UNITED STATES PATENT AND TRADEMARK OFFICE

Office Action Summary	Application No. 10/686,191	Applicant(s) HAGEN ET AL.	
	Examiner Tony G. Soohoo	Art Unit 1797

DETAILED ACTION

4,859,071

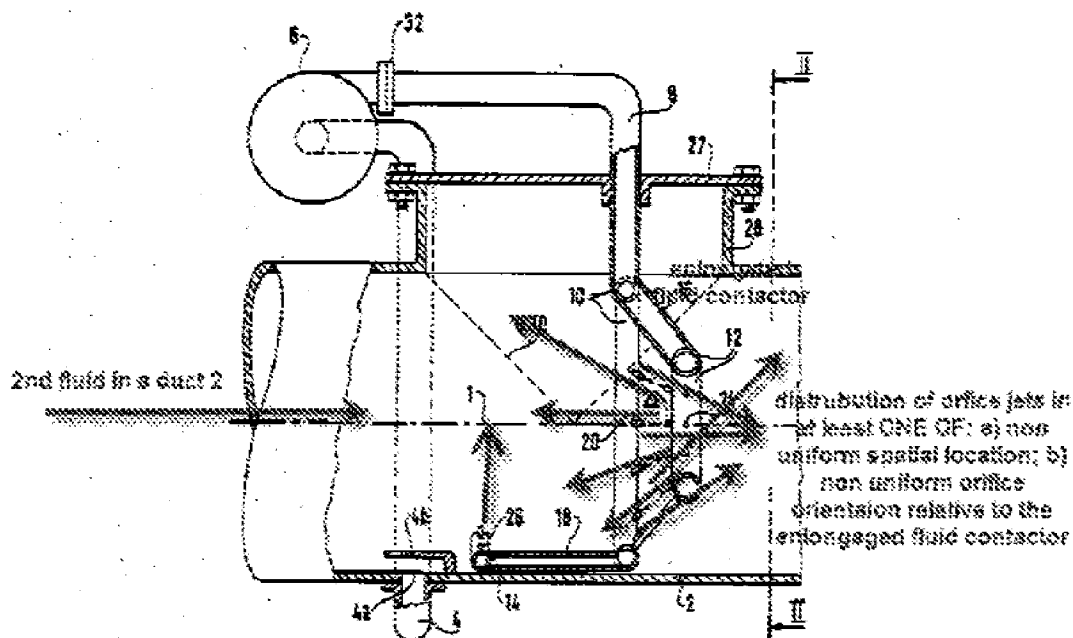
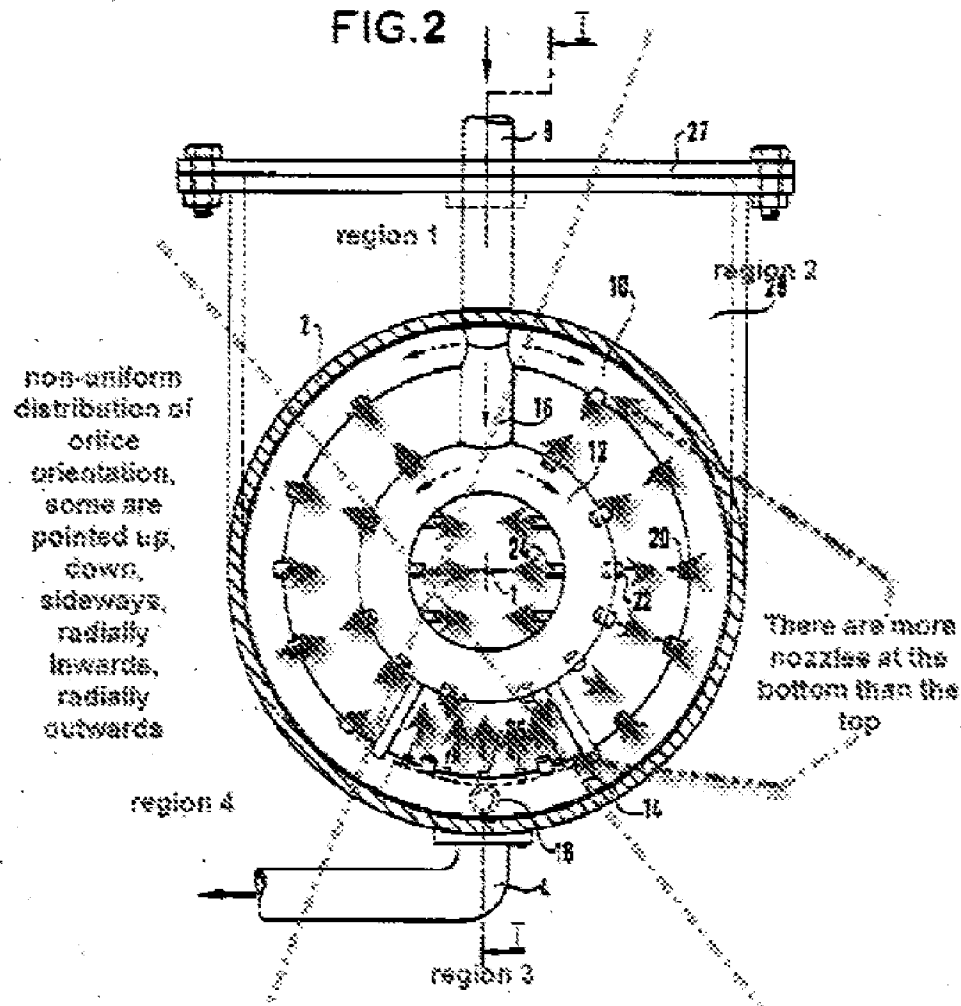
- a fluid delivery system
- a duct 2
- an elongated fluid contactor 8, 10, 12, 16, 18, 14
- an inlet 32
- a plurality of outlet orifices 20, 22, 26 (fig 2) in the elongated fluid contactor

(a) systematically varied, progressively varied, and non-uniform) spatial location (see location of 26 compared to 20, 22, fig 1 and that of locations of 20, 22, and 24) (Note that openings have an orientation position they do not lie in the same plane and lie in different three dimensional locations

(see the directions of 20, 22, 24 and 26 are varied, systematically, progressively and non-uniform, see arrows fig 2), relative to one of the choice of: 1) the axial, 2) radial and 3) circumferential directions of the elongated fluid contactor, excluding a 1st or 2nd orthogonal directions transverse to the mean streamwise flow regions along the curvilinear path along the contactor surface curvature both radially about and circumferentially about the tube surface. (see markup figure

with the distribution angles, position, and sizes of the nozzle are all varied systematically in comparison to the other defined nozzles).

The desired flow distribution of the 1st fluid is provided by a plurality of outlet orifices nozzles, which as seen in figures 1 and 2, by a non-uniform distribution of spatial location and orientation.

16. Phrase "systematically varied" is a comparative term, thus one must establish baseline of measurement and a comparative measurement so as to determine a variation has, in fact, occurred. Since the claim is vague in the frame of reference and prior art shows nozzle orifice in differing locations (there are more orifices per section near bottom than the top across the cross section pipeline, and different orientations (some point up, some point down, some point sideways, see markup figure of Woilles).

18. In fact, applicant acknowledges that some of the nozzle orifices point in opposed to one another. Is it not true that since some of the orifice openings point in one direction, and the other orifice openings are pointed in the other opposite direction, this would mean that the orifices are systematically varied in that some point some point outwards and some point inwards, see nozzles 24/22, or 22/20.

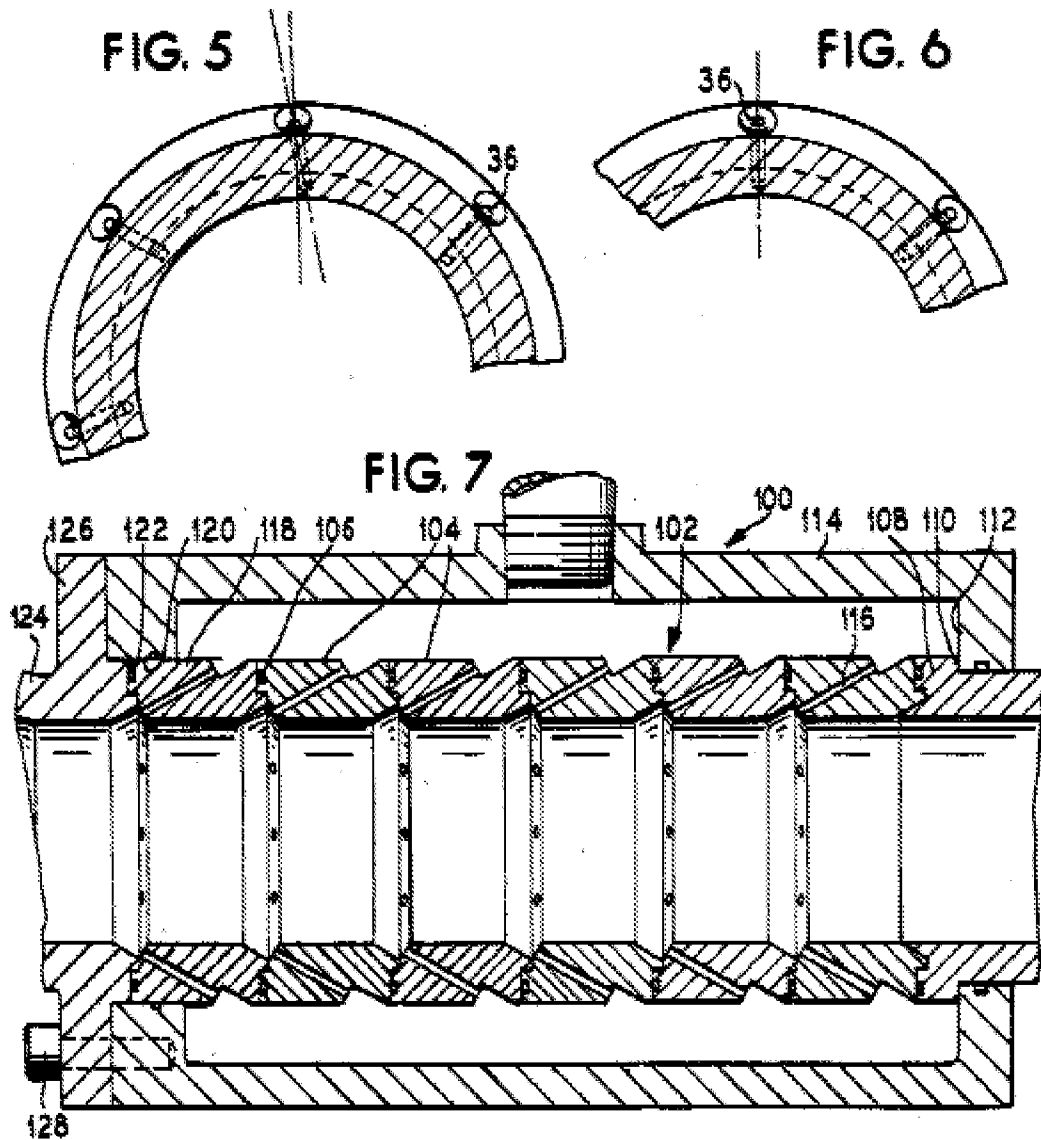
an elongated fluid contactor (Fig 5, 6,7) which forms a flow path for the first fluid
from which the first fluid is delivered into the duct,

a plurality of outlet orifices 36, 36, (figs 5, 6) providing fluid communication

wherein along a first curvilinear direction along , or circumferentially about the
elongated contactor surface (see curve and circumference of figs 5,6, 7), **at least one**
of the distribution of orifice orientation relative to the circumferential direction of the
elongated fluid contactor, is **systematically varied** .

U.S. Patent Jan. 19, 1988 Sheet 2 of 5 4,719,748

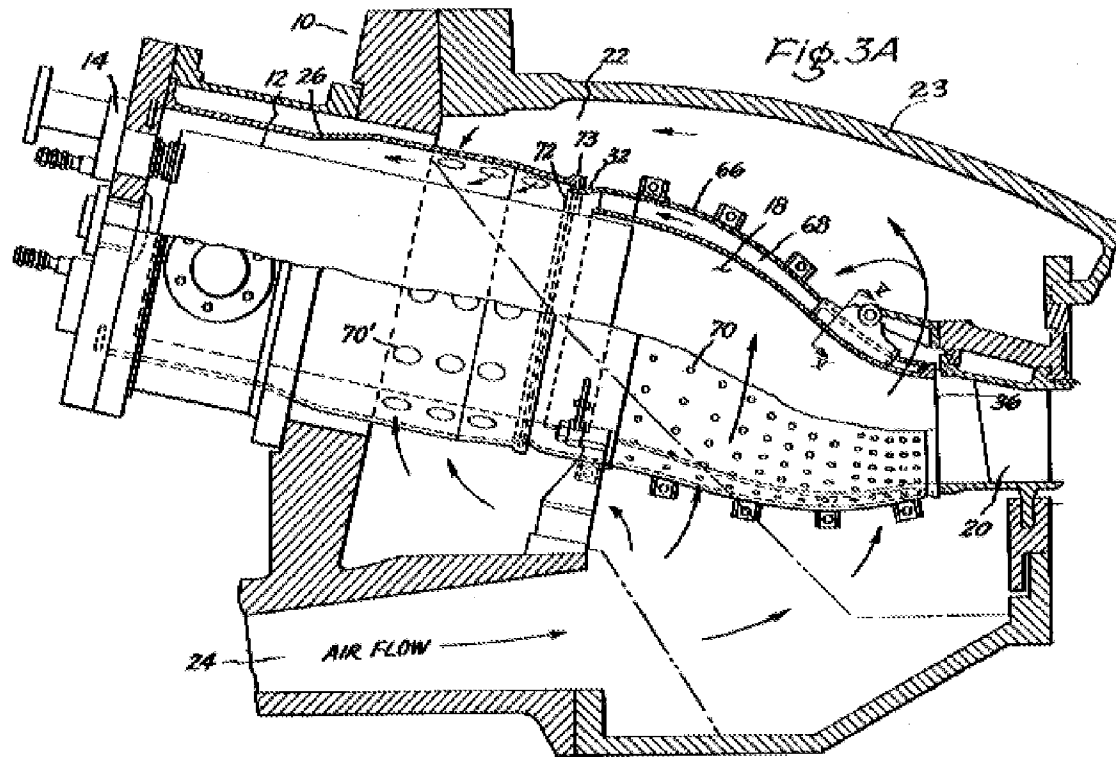
The Davis Jr et al reference (David) shows an apparatus anticipating the claims, see figure 3A, comprising:

an elongated fluid contactor (Fig 3A) which forms a flow path for the first fluid
from which the first fluid is delivered into the duct,

wherein along a first curvilinear direction along , or circumferentially about the
elongated contactor surface (see curve and circumference of figs 3A), **at least one of**
the distribution of orifice orientation, and/or size, and or spacing (see compare plural
aperatues 70, and larger sized apertures 70' and the density of apertures 70 compared
from the left , middle and right of the figure) relative to the circumferential direction of
the elongated fluid contactor, is **systematically varied** .
